SUPPLEMENTAL SHEET
CONTRACT CHANGE ORDER NO. 216
SHEET 18 OF 55

SAN FRANCISCO OAKLAND BAY BRIDGE
EAST SPAN SEISMIC SAFETY PROJECT

YBI TRANSITION STRUCTURES - HINGE K

HINGE K CLOSURE DETAILS NO. 1

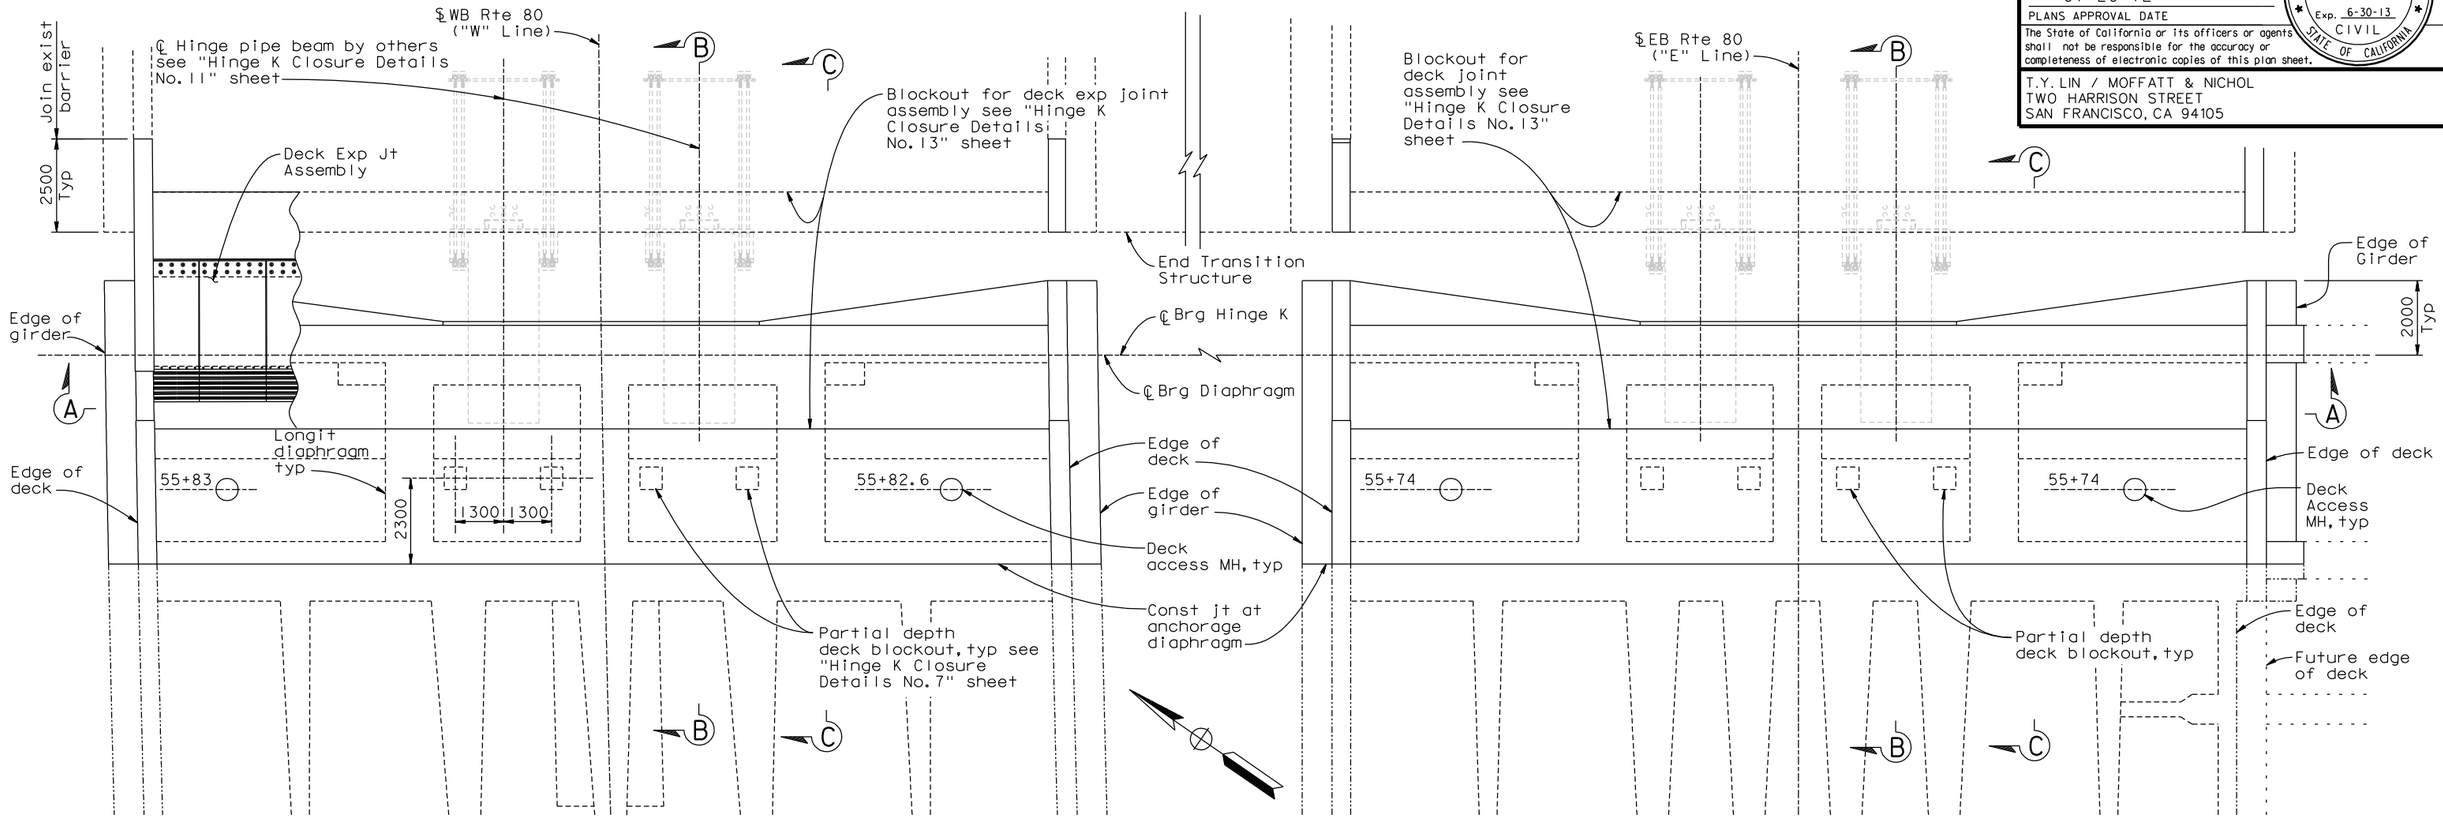
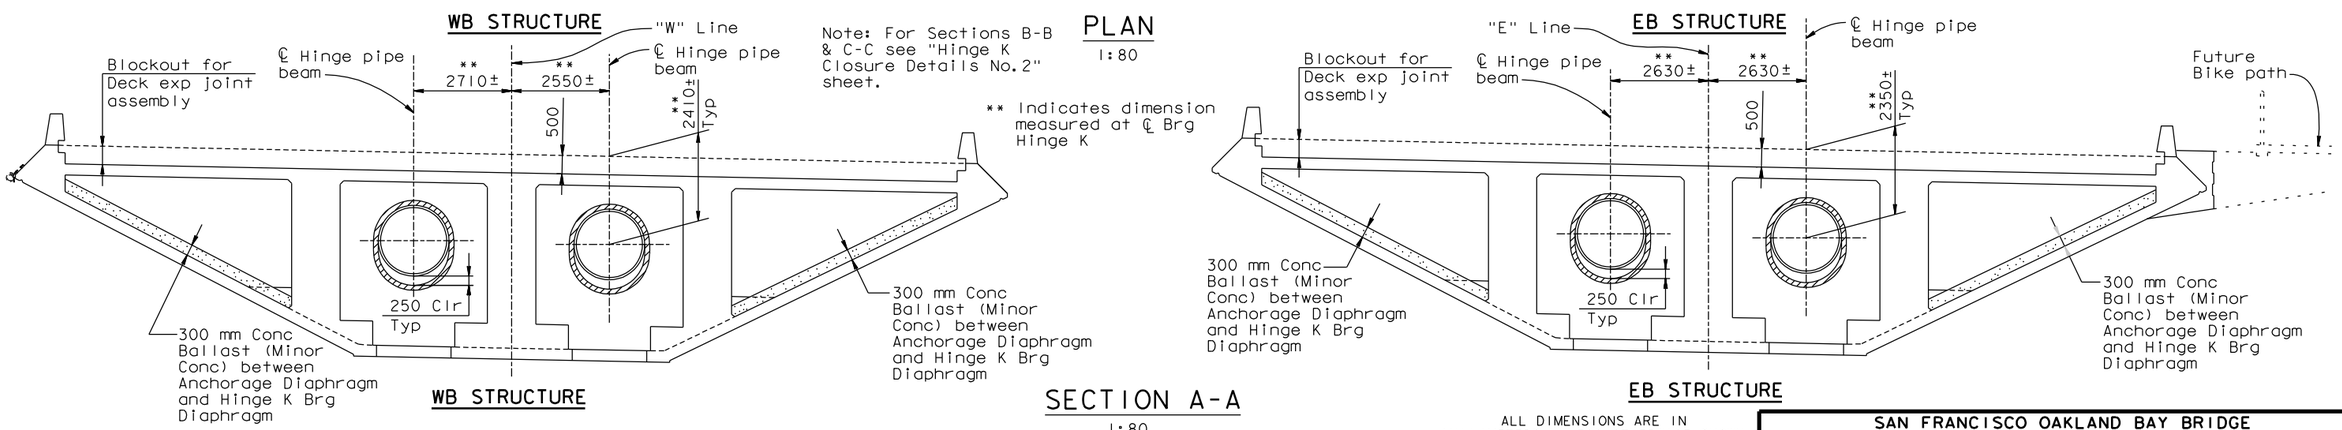
Notes:
- Hinge K closure pour not to be placed until a min of 75 days after prestressing adjacent frame.
- At EB structure, bike path counterweight shall be placed prior to placement of Hinge K closure pour.
- Prior to placement of Hinge K closure concrete, counterweights shall be placed at the cantilever ends of the adjacent frames to balance a portion of the dead load reaction of the closure concrete (approx 13 300 KN). Center of gravity of counterweight to be located at station line for WB Structure and 625 mm south of station line for EB Structure. Counterweights to be removed after closure concrete has attained required strength and prior to falsework release.
- Concrete ballast within Hinge K closure shall be placed after Hinge K bearing assembly is grouted in final position.
